APPLICATION NO.	FILING DATE	FIRST NAMED INVENTOR	ATTORNEY DOCKET NO.	CONFIRMATION NO.
09/910,004	07/23/2001	Andreas Christen	225/50206	1367

Office Action Summary

DETAILED ACTION

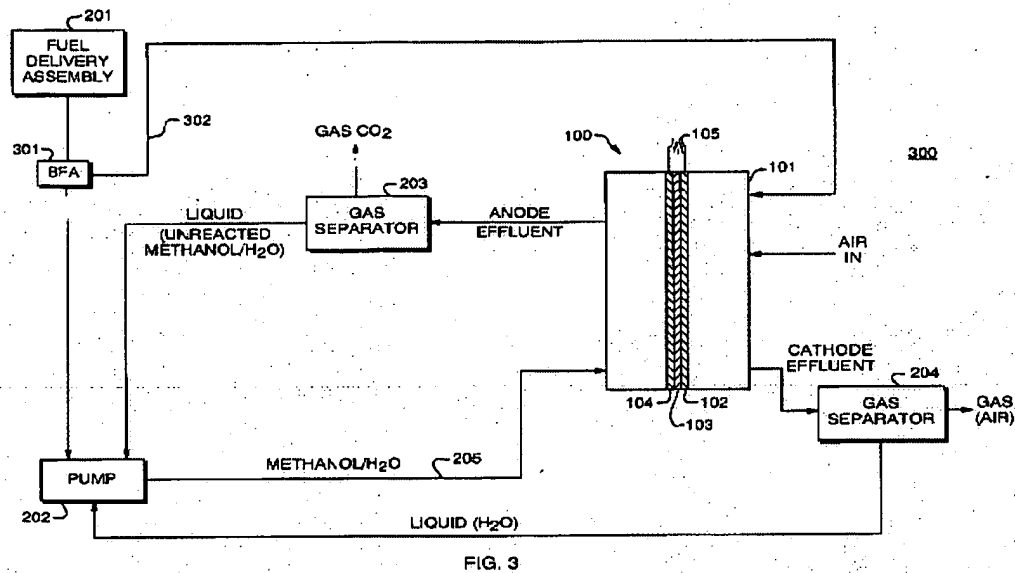
It is evident from **Figure 3** below that the fuel cell system comprises: a) the cathode feed line for feeding oxygen-containing gas to the cathode (*represented by "air in"*); b) the cathode effluent (*the cathode exhaust-gas line*); c) the anode line for feeding (*the fuel conduit 205*) and discharging (*the anode effluent*) an operating medium to the anode-space inlet and from the

Figure 3 shows the BFA 301 (bypass fuel assembly) which supplies fuel to the cathode 102 through a conduit 302 (SECTION 0027) which is connected between the anode line and at least the cathode space (See FIGURE 3).

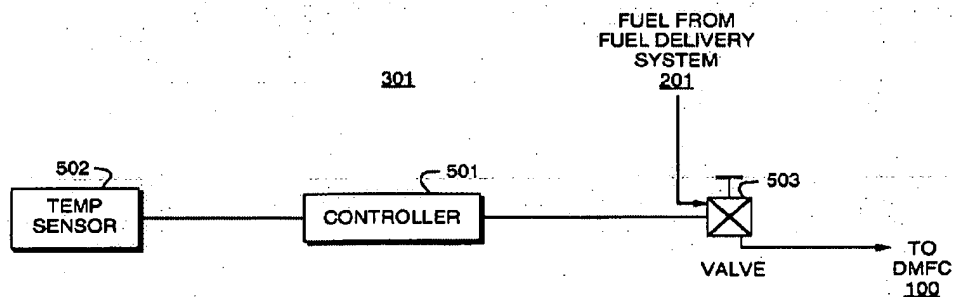
Figure 5 illustrates a block diagram of the bypass fuel assembly 301 including a temperature sensor 502, a controller 501 and a bypass valve 503.

The sensor detects the temperature within the fuel cell and sends a signal indicative of the temperature to the controller. In response to the signal from the temperature sensor, the controller determines whether to direct fuel to the cathode via the bypass valve (SECTION 0009).

FIG. 9

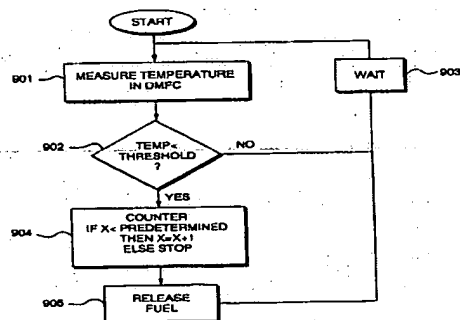
It is disclosed that the sensor detects the temperature within the fuel cell and sends a signal indicative of the temperature to the controller. In response to the signal from the temperature sensor, the controller determines whether to direct fuel to the cathode via the bypass valve (SECTION 0009). **Figure 9** below is a flow chart showing the method for controlling temperature. Accordingly, if the temperature is below the optimal range, controller 501 releases methanol through valve 503 (*that is, the valve is actuated*). It is disclosed that the control valve is either electrically or thermally actuated (SECTION 0012).
